# Planning and Highways Delegations Committee

# Report to Planning and Highway Delegations Committee

This report deals with an opportunity to submit Written Representations to the Planning Inspectorate on proposal by Highways England to upgrade the A47 as part of the Planning Inspectorate's examination of Highways England's proposals, and on the future Development Consent Order (DCO) application for the Sheringham and Dudgeon Windfarm Extension Projects, due to be submitted to the Planning Inspectorate in Q3 2021. The proposals are deemed to be Nationally Significant Infrastructure Projects (NSIPs) and applications for development consent will be determined by the Secretary of State.

Appendix B: Wood Lane Junction showing connection to Norwich Western Link (in pink)

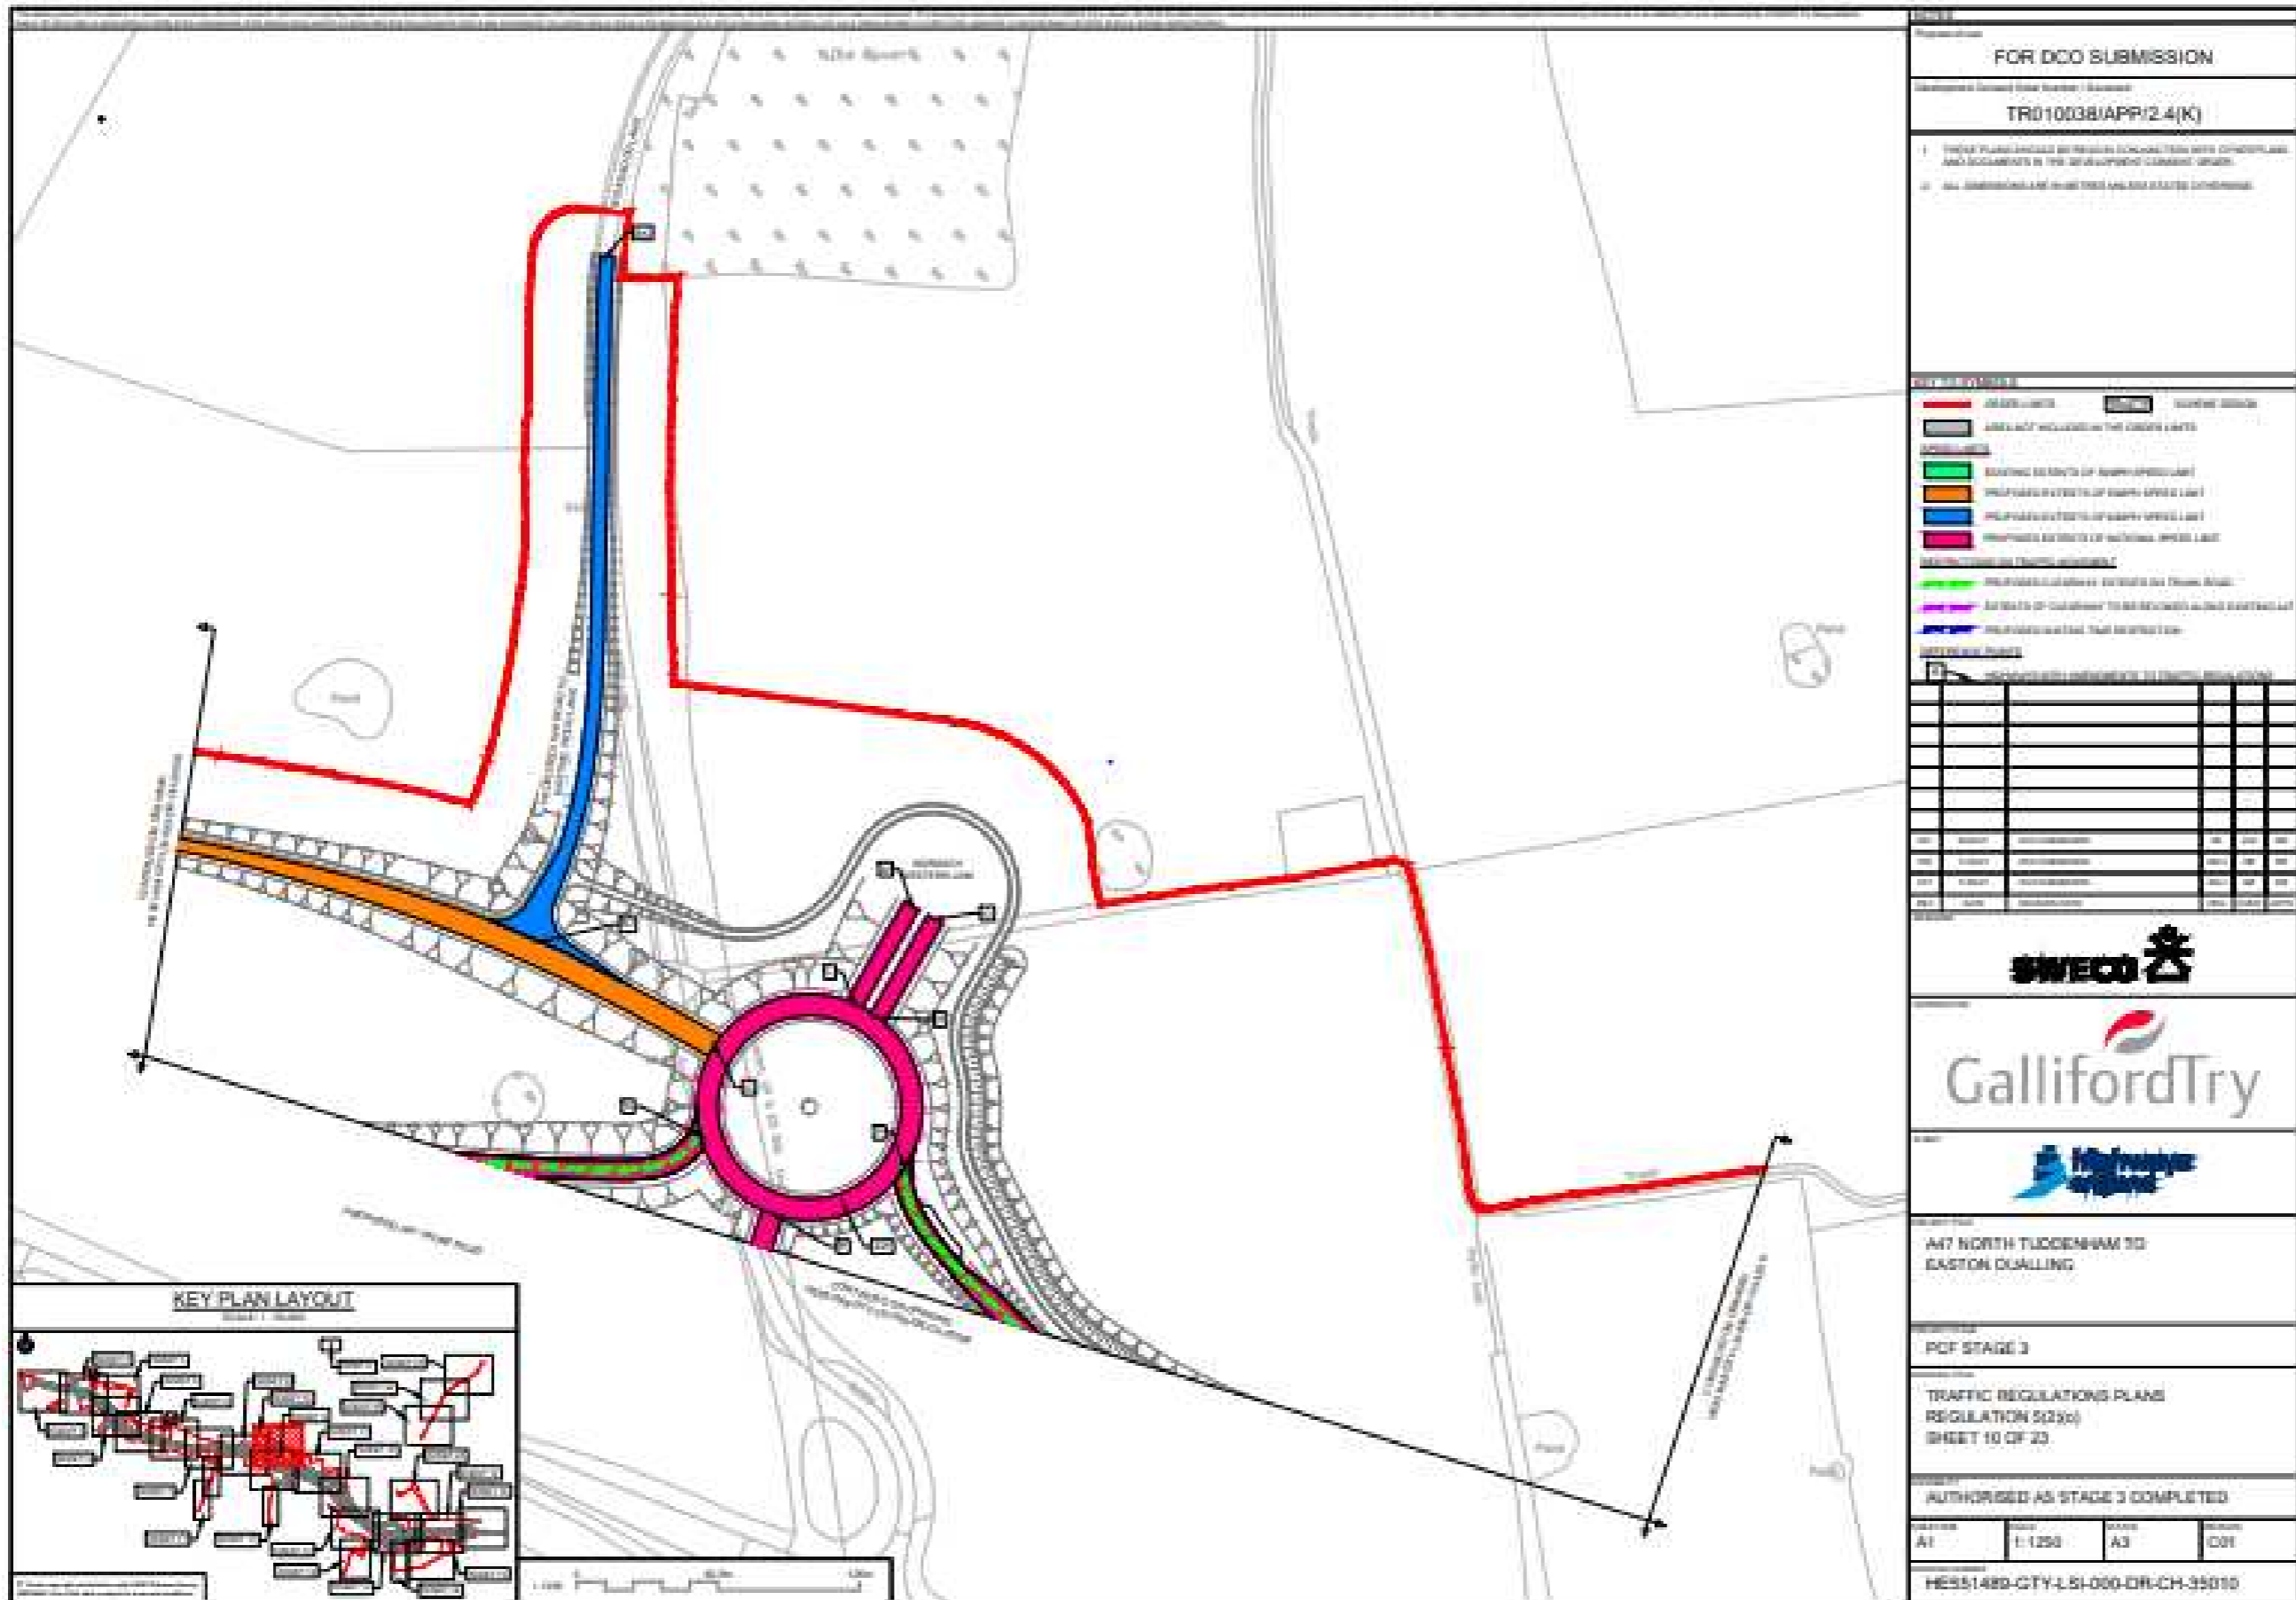
The A47 scheme includes a proposed cycle track between the realigned Wood Lane and Hall Farm Underpass. This is shown as looping round the NWL arm of the Wood Lane junction. In discussions with Highways England, Norfolk County Council understands that this is a temporary arrangement and, on completion of the NWL, will be superseded by the permanent facilities being planned as part of the NWL scheme.

However, we have concern that local users will not appreciate the temporary nature of Highways England's proposals in this area and would expect Norfolk County Council to provide a crossing of the NWL at the proposed A47 Wood Lane junction. This is not supported by the county council.

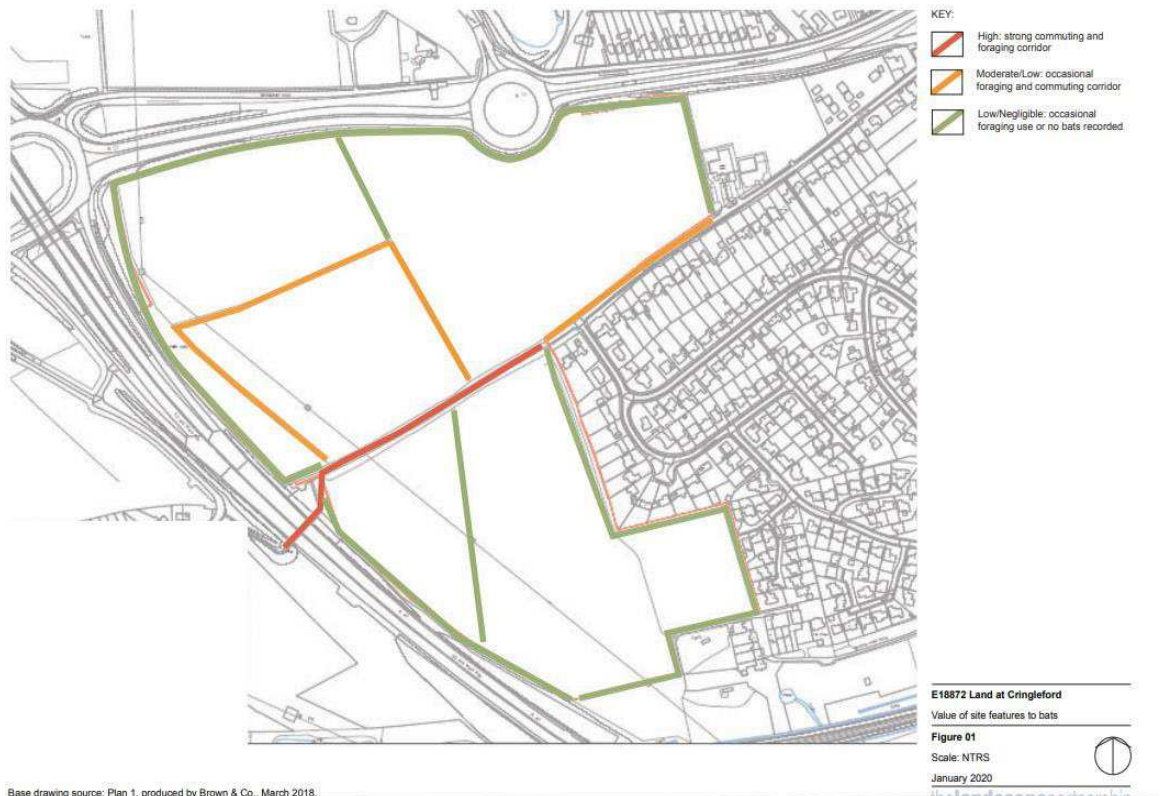
- Para 8.7.5 does not elaborate on how areas of 'high' bat activity was quantified.
- Table 8-9. (page 42) great crested newt. Notes that attenuation ponds are proposed as enhancement for great crested newts but it is not clear whether they will contain standing water, and for how long. Also, Table 8-12 (page 56) notes that the attenuation ponds are designed to reduce pollution entering nearby water courses, and as such would not provide suitable enhancement for great crested newts. There is no mention of enhancement of SuDS/attenuation ponds for great crested newt this in the Record of Environmental Actions and Commitments (REAC) in the Environmental Management Plan.

- Table 8-9 notes the translocation of 5m of important hedgerow but does not explain where this will be translocated to.
- Table 8-9 (page 39) notes that a UKPN cable is being installed within the CWS. It is not clear which CWS is referred to and this has not been previously mentioned in Chapter 8 or Chapter 15 – Cumulative Effects Assessment. Note: it is mentioned in B11 Table 3-1: Record of environmental actions and commitments

Environmental Statement - Appendix 8.1 Botanical Survey Report.pdf:

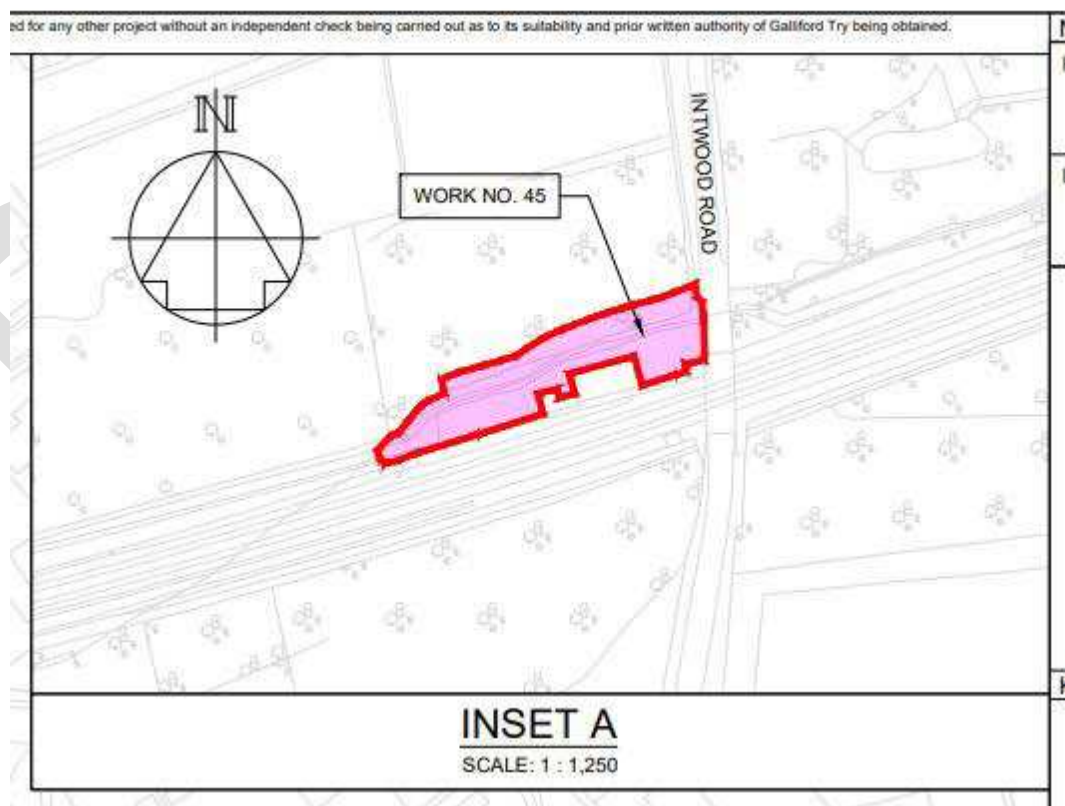
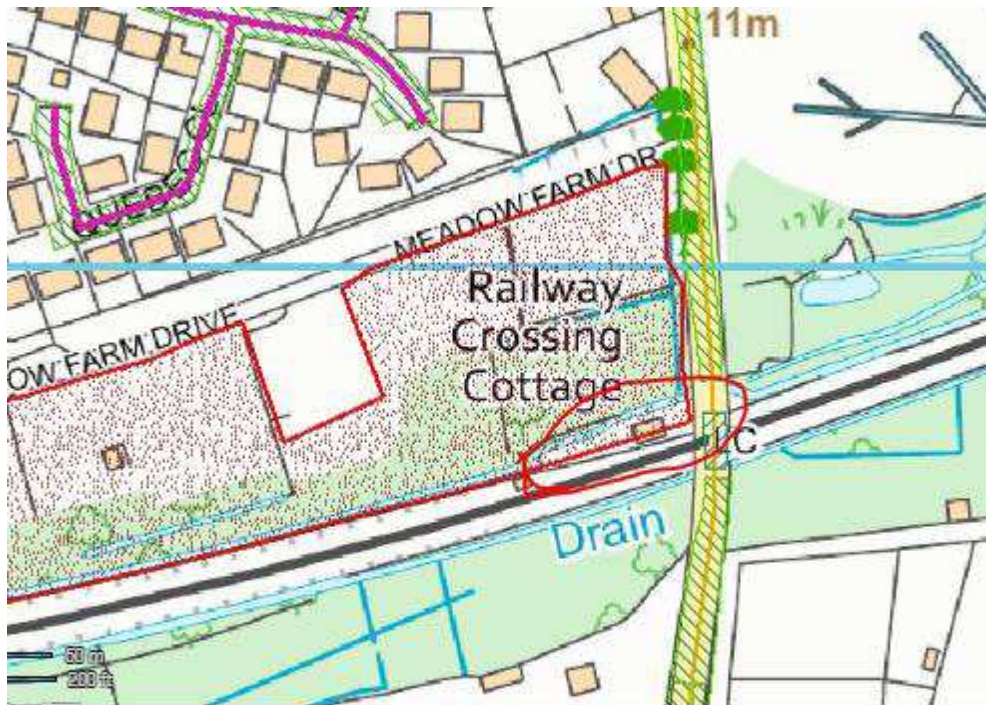
- The survey area (see figure 1a, page 9) differs from the current DCO red-line site boundary (see General Arrangements Plan).
- It is noted that Areas 'G' and 'I' are of district value, as is Meadow Farm county wildlife site (CWS).

- Hedgerows H2, H3, and H6 likely to be of ecological importance under the Hedgerow Regulations 1997 although it is not clear which hedges these refer to, or which hedges were surveyed as no plan showing, for example, H1, H2, H3... etc. has been provided. The Volume 2 2.12 Hedgerow Plans document does not use the same system (H1...H2) to identify hedges.

Figure 2b

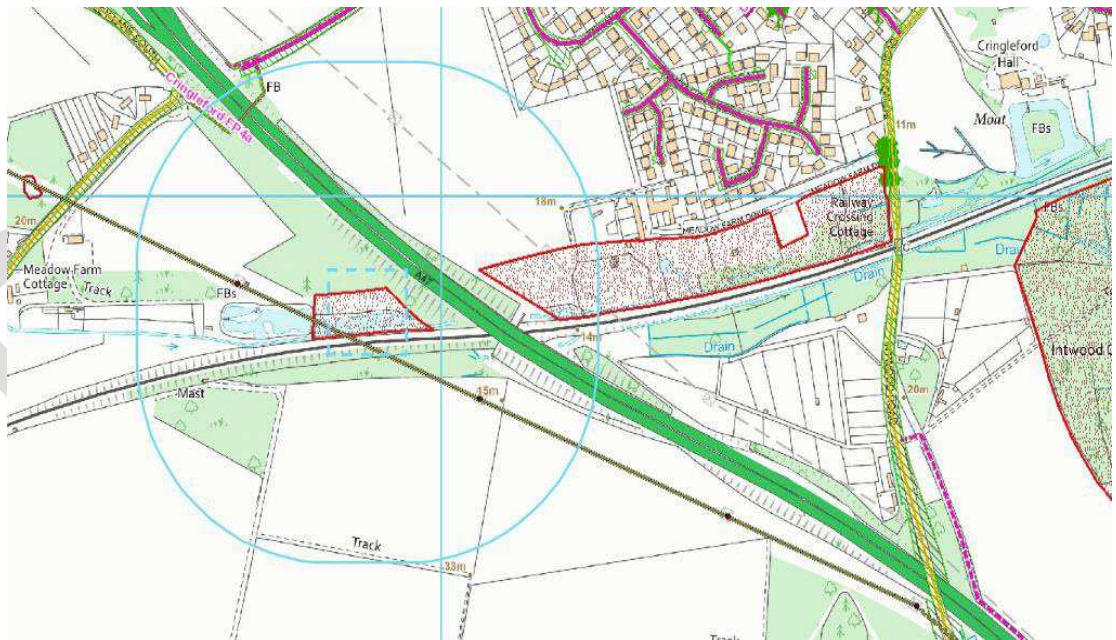
- Work Nos. 6 and 40 may also impact Meadow Farm CWS. Work No 49 abuts Meadow Farm CWS. Work No. 42 directly impacts Meadow Farm CWS and is associated within utilities diversion – it is not clear if this is associated with the UKPN cable route.
- Meadow Farm CWS is only shown to the right of the A47 (top, below). However, it extends to the left of the A47 as shown (bottom, below). This will affect the impact assessment and mitigation requirements.

- Para 7.6 also notes 'The southern edge of Area N, a priority habitat and potentially ancient woodland (present since at least 1840) will be impacted by a new road. This will be an intermediate impact on this feature. Mitigation is advised' the potential presence of ancient woodland is not mentioned elsewhere and Chapter 8 only refers to veteran trees on the ancient woodland inventory (para 8.7.14)
- It should be established if this woodland is ancient and the scheme re-designed to avoid this area as recommended in section 8 of the botanical

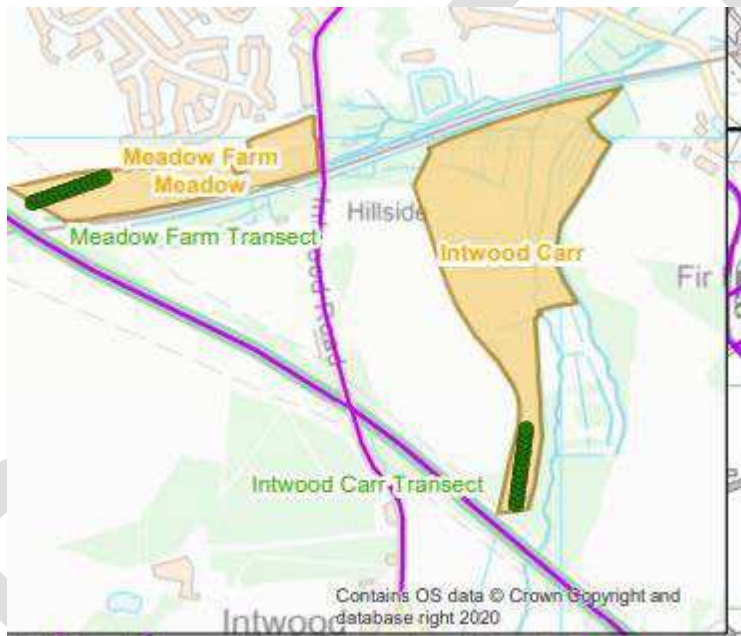
- Para 3.4.8 (below) - It is not clear why reference has been made to Bechstein bats as this species is not present in Norfolk. We (the Natural

Environment Team) were consulted in January 2021 with regards to the Long List. During this consultation we queried the use of a 2km CEA ZOI, suggesting the Core Sustenance Zones of bats is used. No mention was made to Bechstein bats.
